# Official Journal of the European Union

## COMMISSION IMPLEMENTING REGULATION (EU) 2018/502

**amending Implementing Regulation (EU) 2016/799 laying down the requirements for the construction, testing, installation, operation and repair of tachographs and their components**

Figure 1

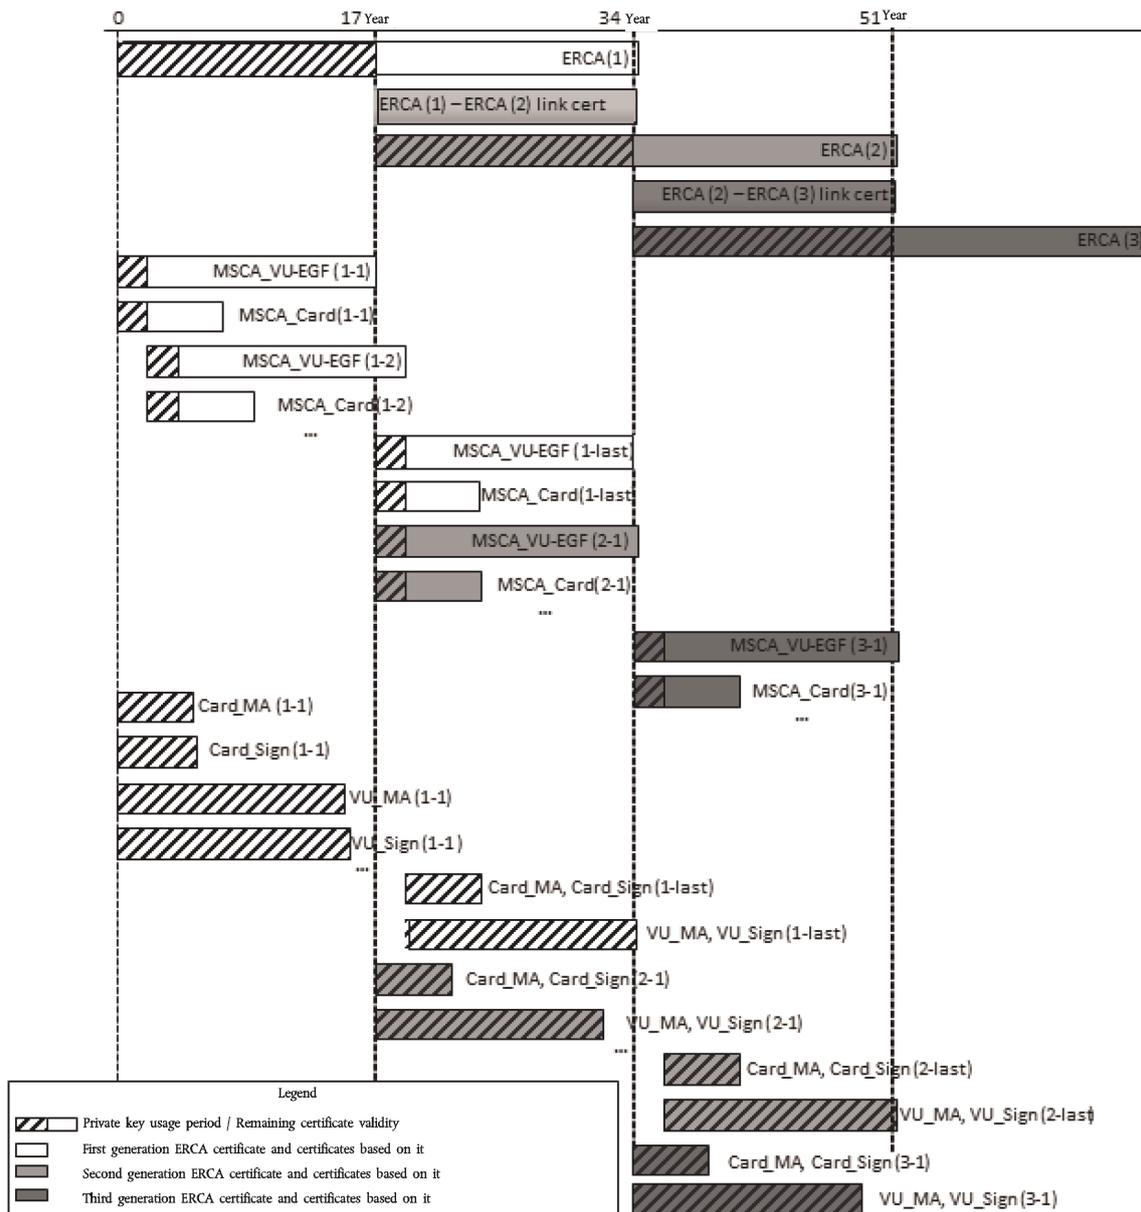
(i) Figure 1 is replaced by the following:

**Issuance and usage of different generations of ERCA root certificates, ERCA link certificates, MSCA certificates and equipment certificates**

Figure 6

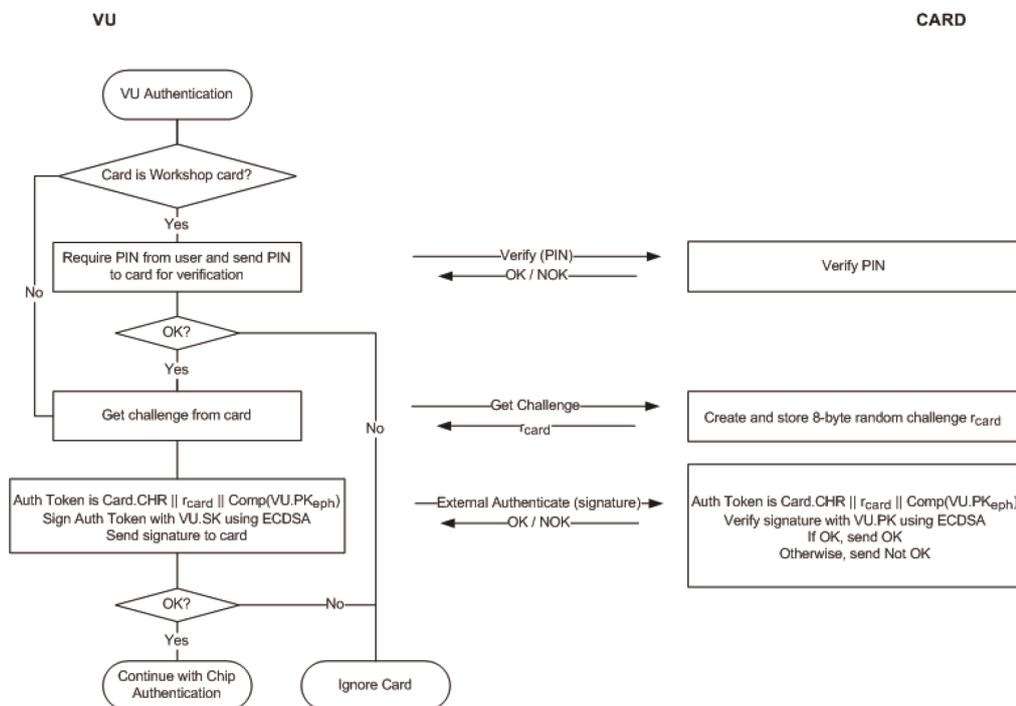
(ii) in paragraph CSM\_171, Figure 6 is replaced by the following:

### VU Authentication protocol

Figure 13

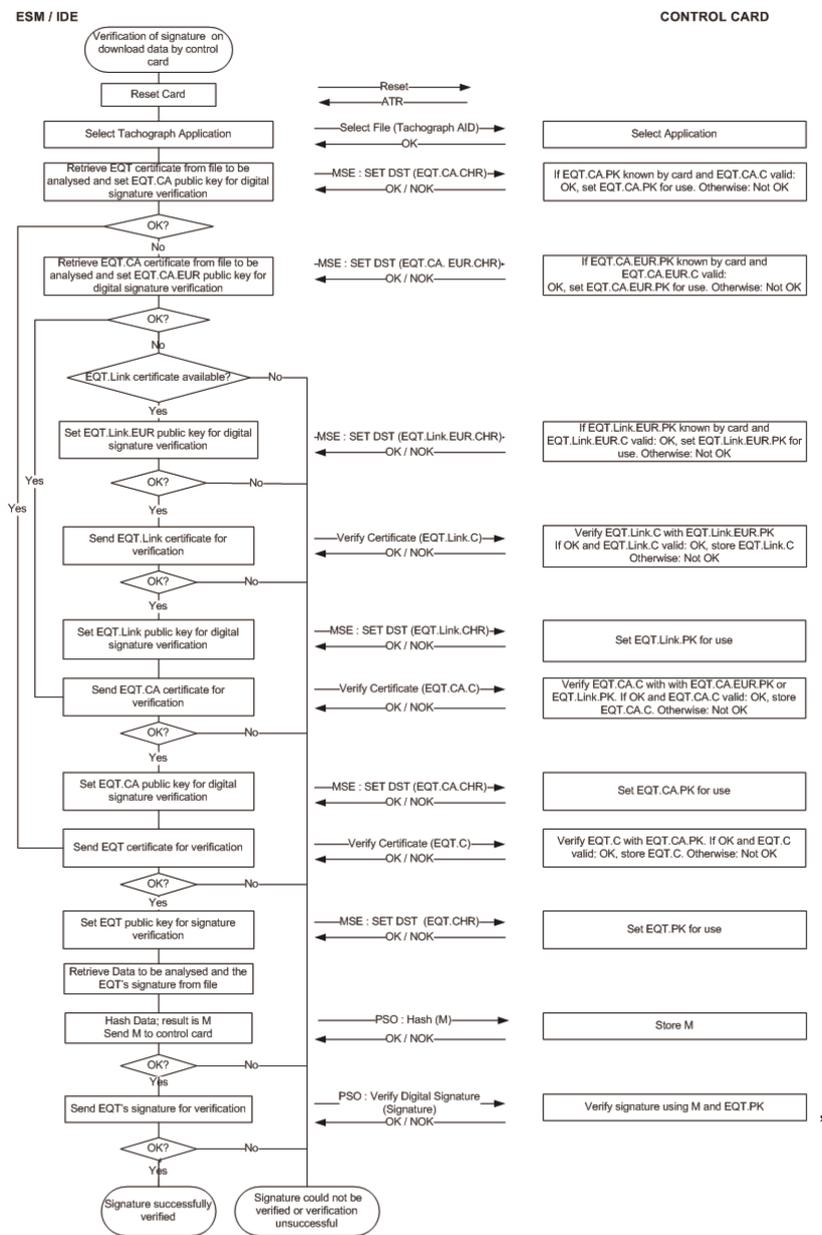
(ii) Figure 13 is replaced by the following:

Protocol for verification of the signature over a downloaded data file
